Review of AEMO's Power System Model Guidelines and System Strength Impact Assessment Guidelines

Prepared For:

Babak Badrzadeh
Manager – Operational Analysis and Engineering
Australian Energy Market Operator
T +61 (0)3 9609 8344
M +61 (0) 466504953
babak.badrzadeh@aemo.com.au
www.aemo.com.au

Figure 4: Simulation and measured response of an individual wind turbine generator in another wind power plant where the same test as shown in Figure 2 was performed. (© IEEE 2018, reproduced with permission)

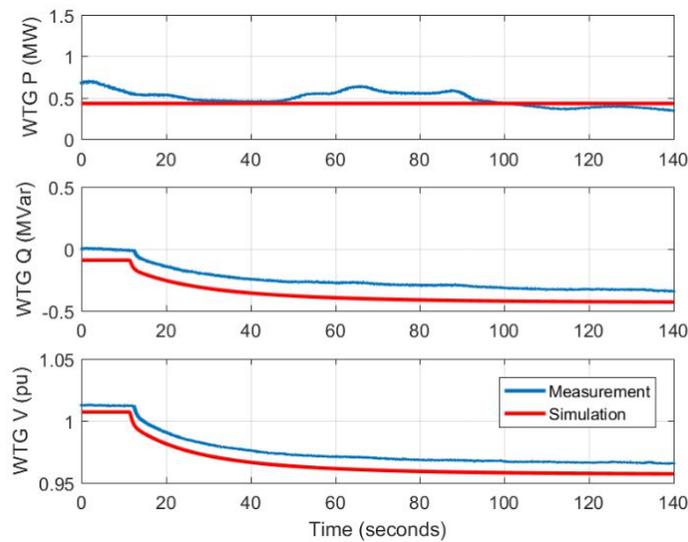
4. In subsection 4.7.3 it is stated that “*For model validation purposes, both the individual generating unit and aggregated generating system response must conform to the accuracy requirements in Section 6.2.*” We offer the thought that some level of flexibility and engineering judgement must be exercised here. Take as an example the results shown in Figure 2, Figure 3 and Figure 4. Figure 2 shows the validated response of the aggregated wind power plant model for simulating a plant level voltage response at the point-of-interconnection (see Figure 5). Figure 3 shows the response, as measured at the same time, of two individual wind turbine generators (WTGs) in the plant and how this compares to the scaled down response of the aggregated WTG in the model (see Figure 5). In this case fortuitously the responses match well. Figure 4 shows an example of an individual WTG response

where the actual measured response is quite a bit offset from the simulated aggregated WTG model, even though the response at the point-of-interconnection (POI) was just as good as that in Figure 2. The reason is simple. The equivalent feeder model, derived using the so-called NREL method¹⁸, is able to give a reasonable representation for modeling the plant’s response at the POI, however, it is unreasonable to assume that it will be able to adequately capture the exact steady-state voltage and reactive profile at every point in the collector system. Thus, in some cases one will be lucky and see a response such as Figure 3 and in others one will see an offset in voltage and reactive power as in Figure 4. Nonetheless, the dynamic response of the individual WTGs is adequately captured. This can be further illustrated by other tests too, such as a capacitor switching test which invokes a “true” grid voltage jump (see Figure 6). This is all said to illustrate the fact that an aggregated model of a wind (PV) power plant, which is typically what is needed for power system simulations (and actually specified in the AEMO document) cannot give the same level of accuracy at both the POI and the individual turbine/inverter level. Thus, there must be flexibility here in understanding the goal and objective of the model.
